Amendments to the Drawings:

**REMARKS/ARGUMENTS**

**FIG. 2**

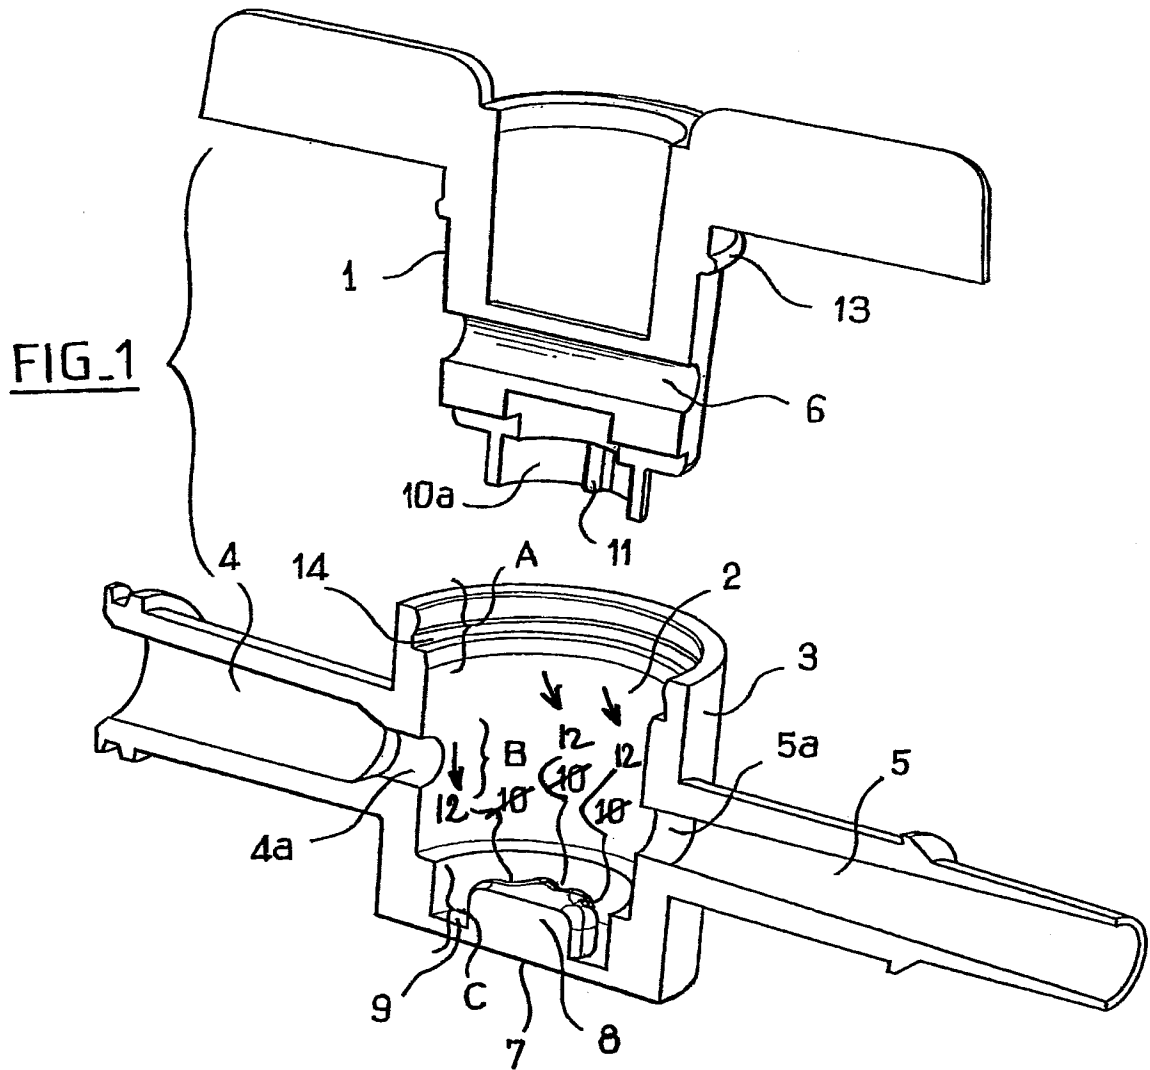
The attached sheets of drawings includes changes to Figs. 1 and 2. These sheets, which include Figs. 1 and 2, replace the original sheets including Figs. 1 and 2. In Figures 1 and 2, reference numerals 10 have been changed to 12.

Objection was made to the drawings due to the use of reference numerals 10 and 12 to designate notches on the raised element 8. New drawings are submitted herewith in which reference numeral 10 has been changed to 12.
